BUSINESS CONDO CONVERSION

1000 Laconia Road Sanbornton, NH 03269 Project Status 02/27/2024

RE: Engineering Judgment - Evaluation and Upgrade of Existing Interior Walls **Business Condominium Building Conversion** 1000 Laconia Road Sanbornton, Belknap County, New Hampshire

Laconia Road 2-HR Wall EJ January 23, 2024 Page 2 of 7

FIGURE 1 - Typical Proposed 2-Hour Wall Detail

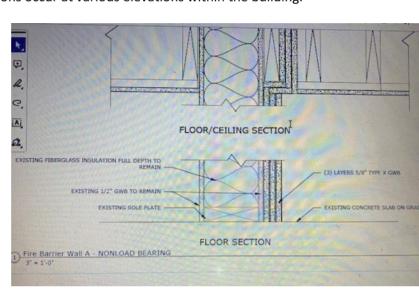
symmetrically to both sides of the wall systems to achieve the fire resistance rating (FRR) in some areas. The details show a typical 2-hour wood-framed wall in the attic space (similar to UL Design No. U306 and UL Design No. U338). In areas with existing walls, it is proposed to add additional layers of gypsum board to the accessible side of the wall and noncombustible cavity insulation to upgrade the FRR. Sketches of the proposed design have been provided for Intertek's review and analysis. Figure 1 shows a typical proposed detail (Sheet A502) integrating existing conditions with improvements to obtain a 2-hour FRR. Similar conditions occur at various elevations within the building.

The existing base wall is a thermally insulated, non-load bearing, 2x6 wall system (or floor joists). We would estimate the fire resistance of the existing wall at 45 minutes minimum. We would estimate the three layers of gypsum board added to the existing condition as having a minimum 75-minute FRR. Therefore, in our professional opinion, the required 2-hour FRR will be achieved with the design as proposed by KOAL pllc.

In our professional opinion, the existing wall system can be upgraded to a minimum 2-hour fire resistance rating by the addition of three layers of 5/8" Type X gypsum board. The installation details found in UL Design No. W415/GA File No. WP 1713 should be followed. These details include, but may not be limited to Board orientation, horizontal and vertical joint staggering, fastener length, and fastener spacing.
